WEST WASHINGTON AVENUE AND HENRY STREET RESURFACING ASSESSMENT DISTRICT - 2024

**ADDENDUM NOTE:
ADDED EXCAVATION CUT TO ACCOMMODATE GRADING CHANGES**

CITY PROJECT NO. 14389
CONTRACT NO. 8746

14389
P-2

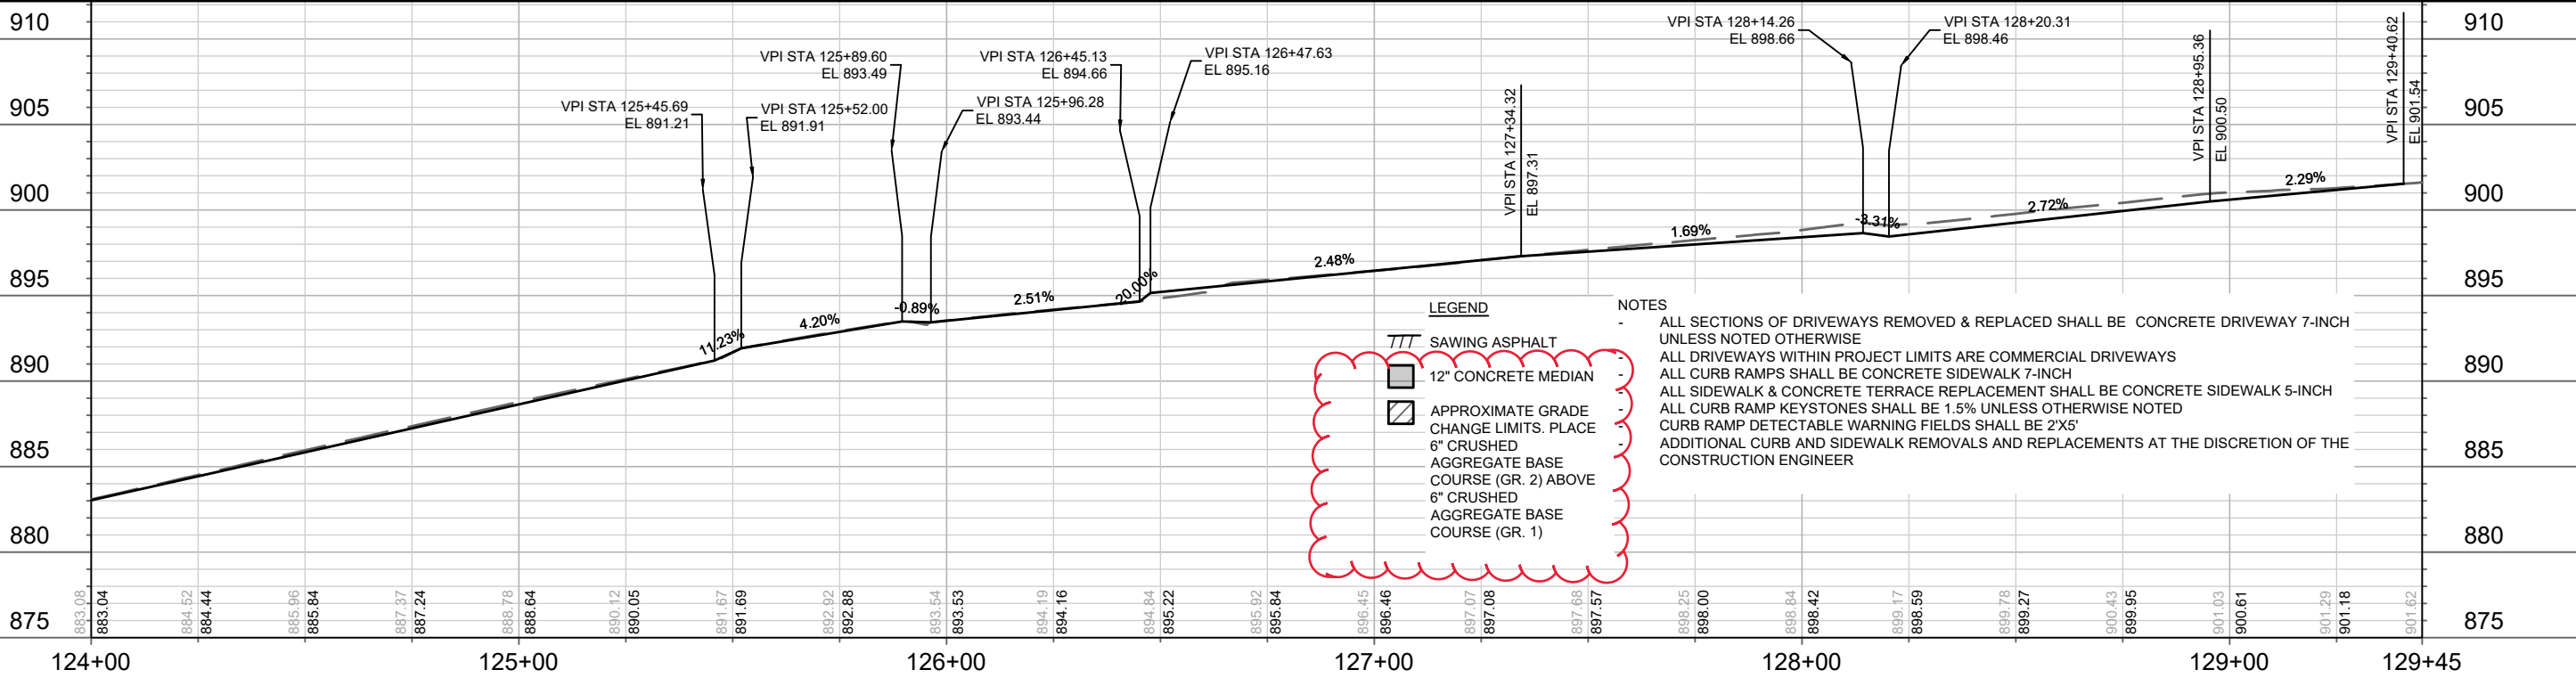
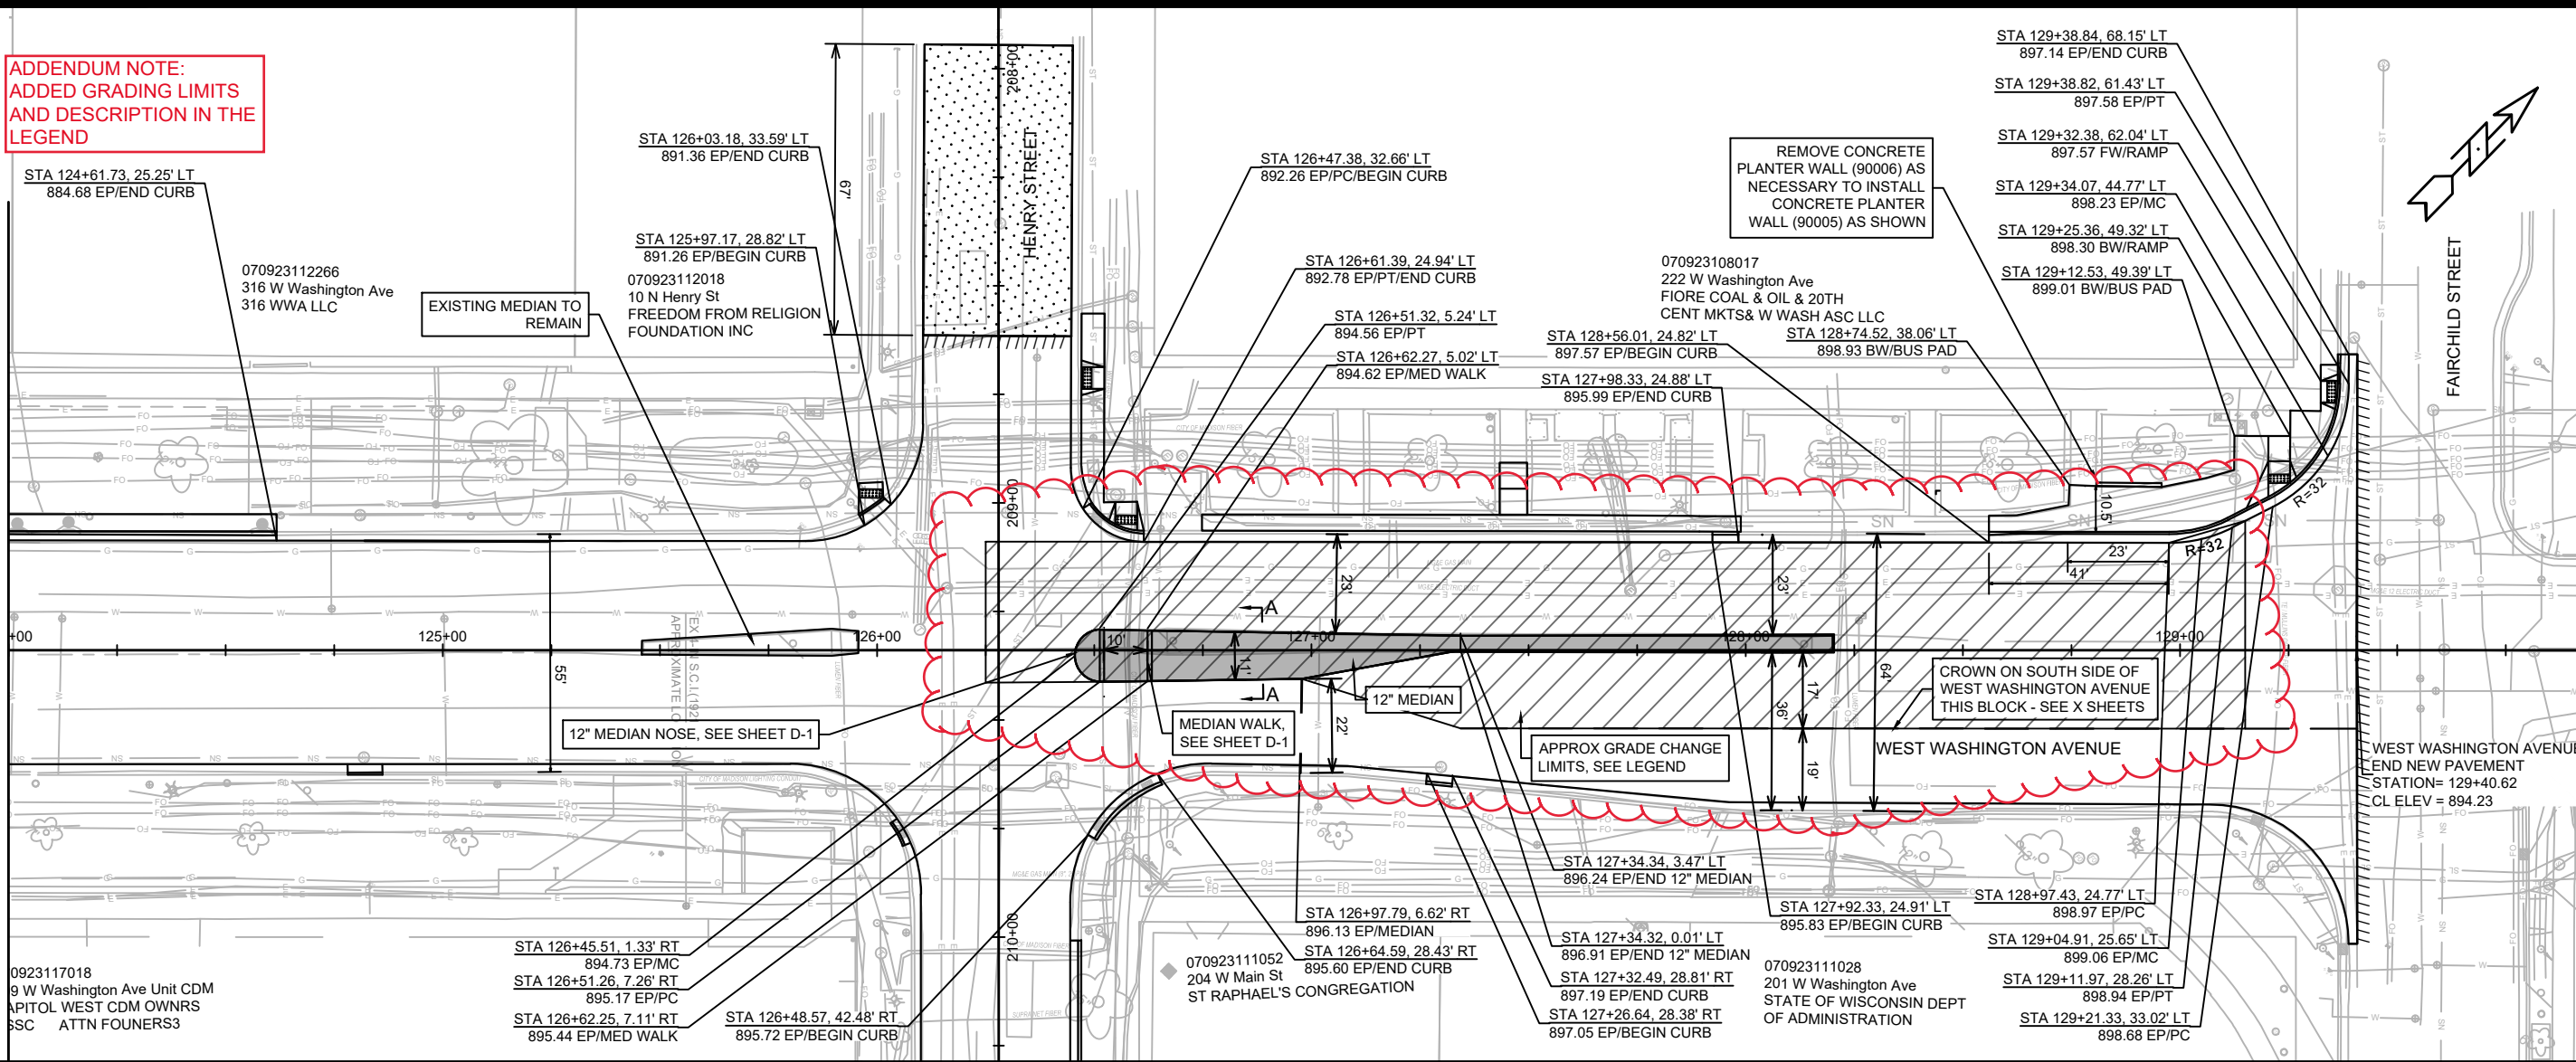
**ADDENDUM NOTE:
ADDED GRADING LIMITS
AND DESCRIPTION IN THE
LEGEND**

- SAWING ASPHALT
- ▬ 12" CONCRETE MEDIAN
- ▨ APPROXIMATE GRADE CHANGE LIMITS. PLACE 6" CRUSHED AGGREGATE BASE COURSE (GR. 2) ABOVE 6" CRUSHED AGGREGATE BASE COURSE (GR. 1)

14389
 X-7

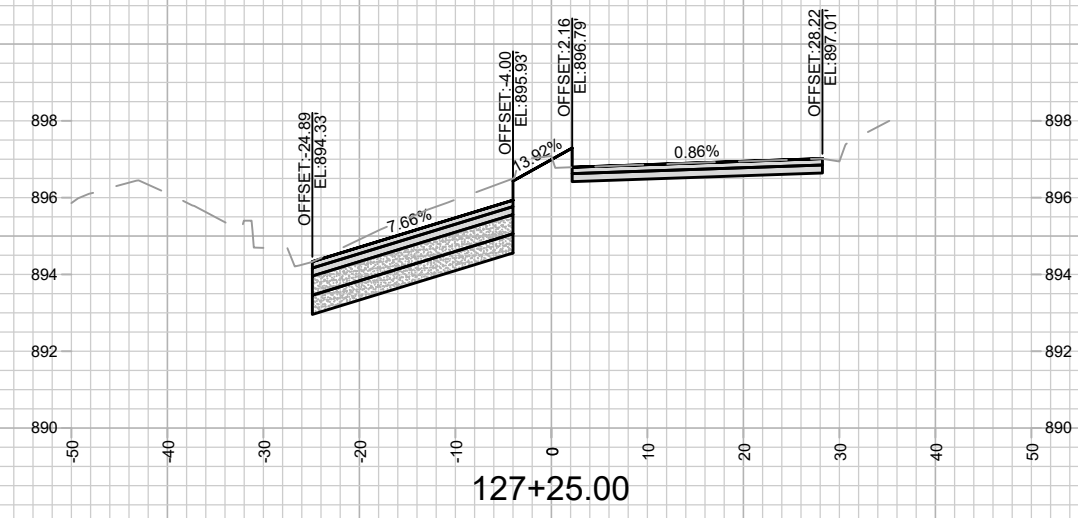
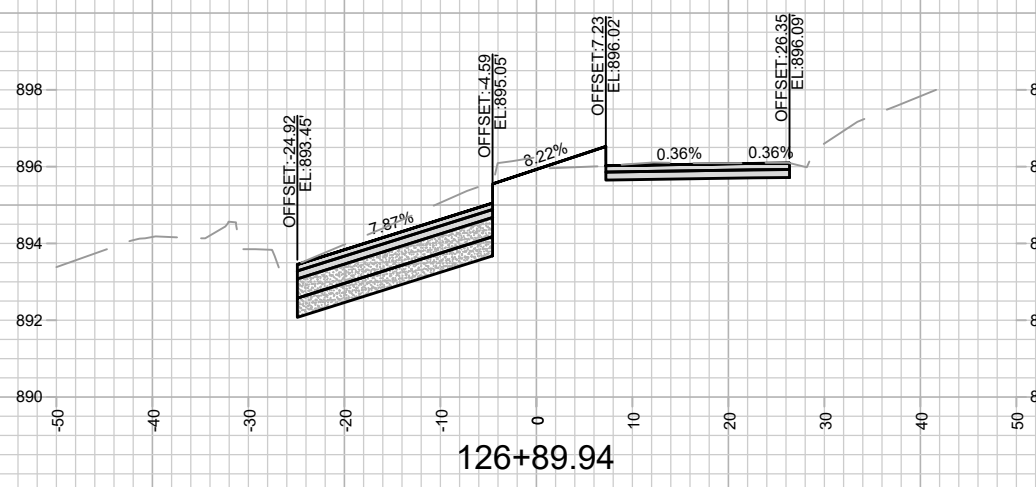
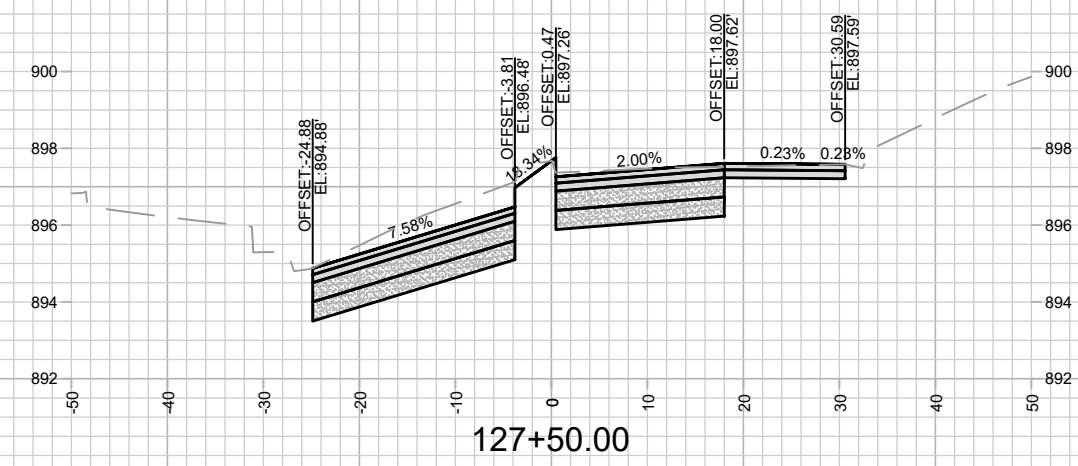
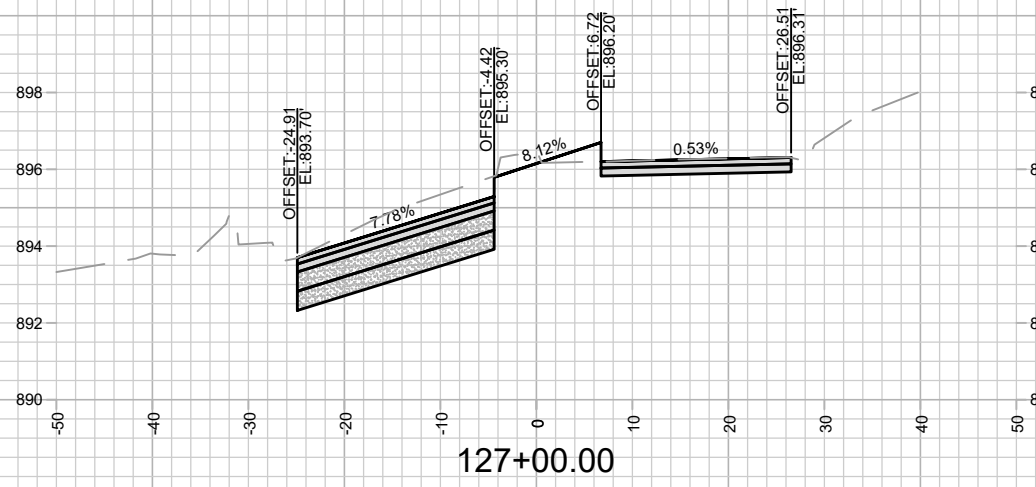
ADDENDUM NOTE:
ADJUSTED GRADES TO
REDUCE CROSS SLOPES

Designed By: MFG Date: 3/25/2024 5:24 PM
 14389
 Scale: 1" = 20'
 X-8

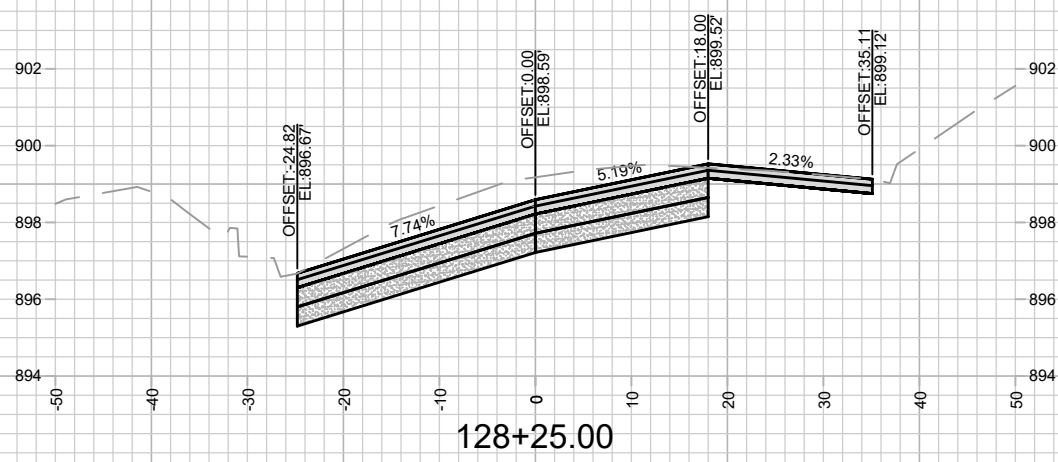
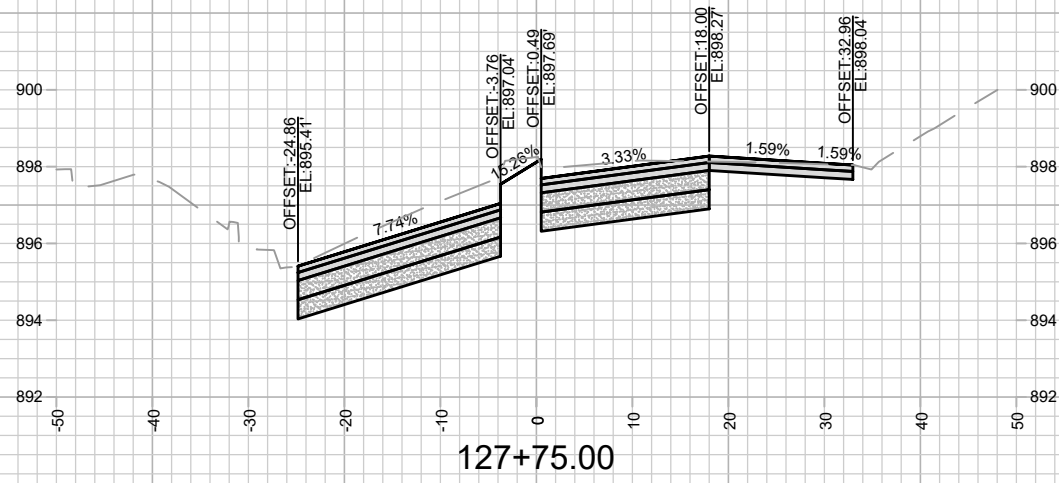
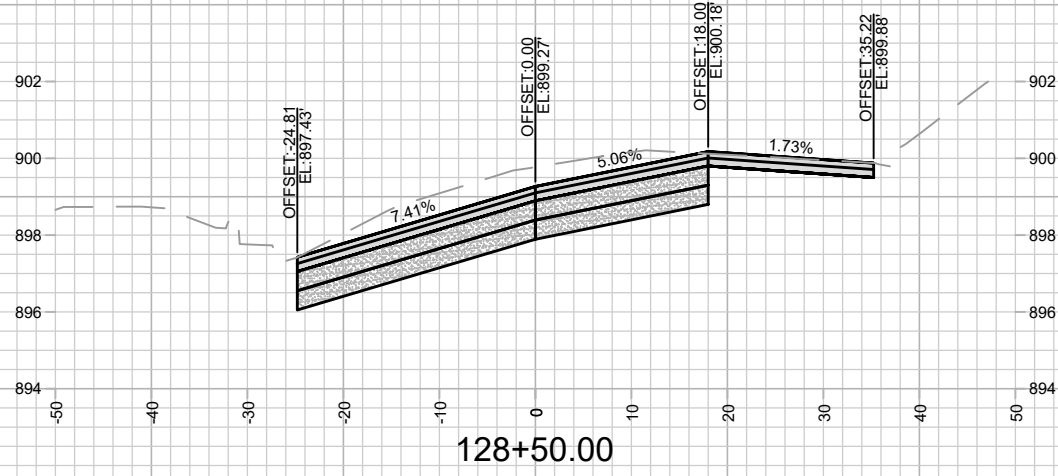
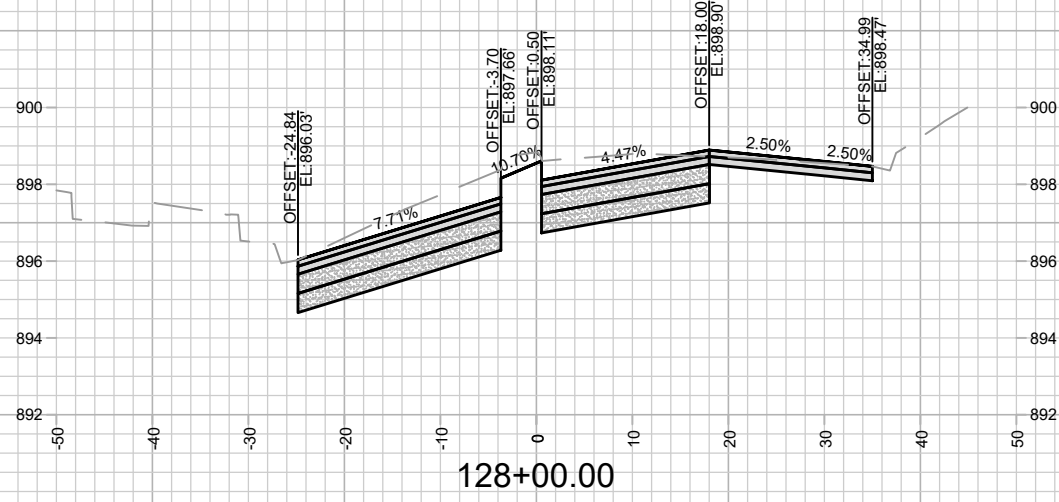
ADDENDUM NOTE:
ADJUSTED GRADES TO
REDUCE CROSS SLOPES

14389
 X-9

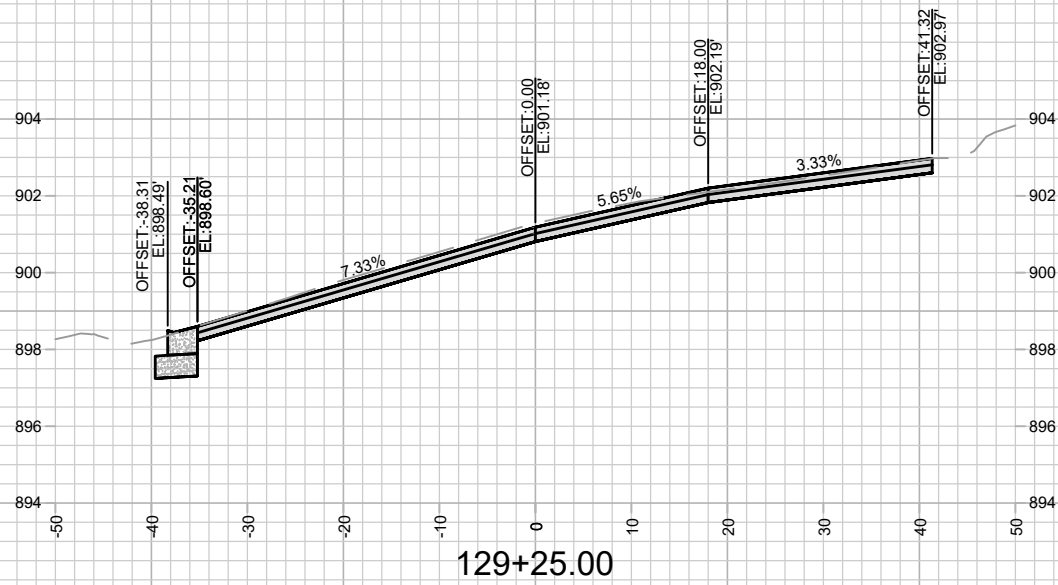
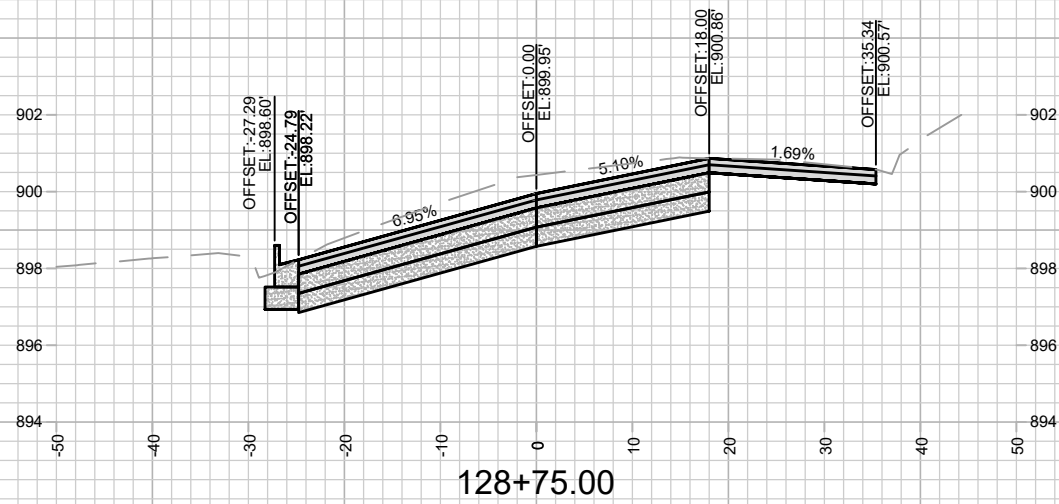
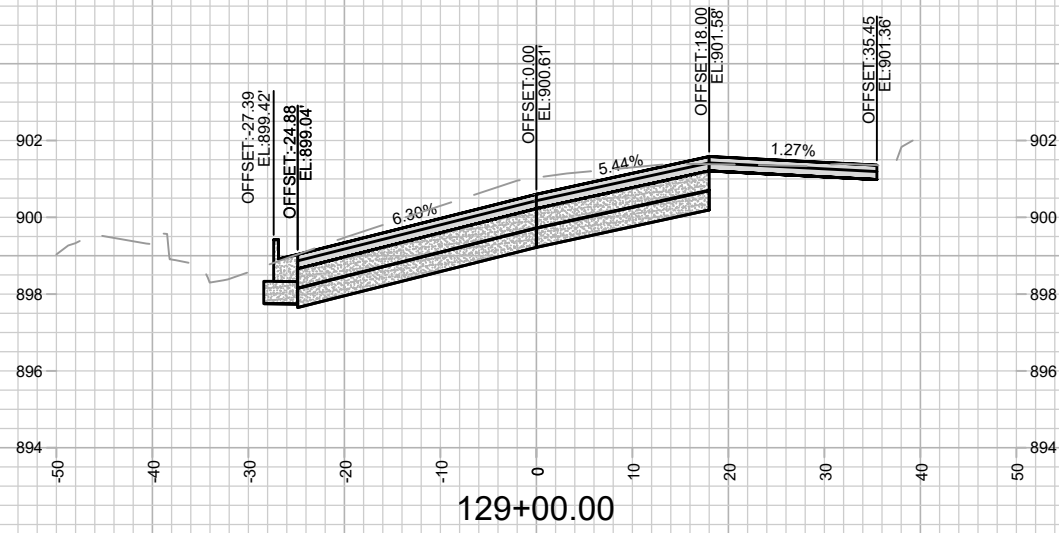
ADDENDUM NOTE:
ADJUSTED GRADES TO
REDUCE CROSS SLOPES
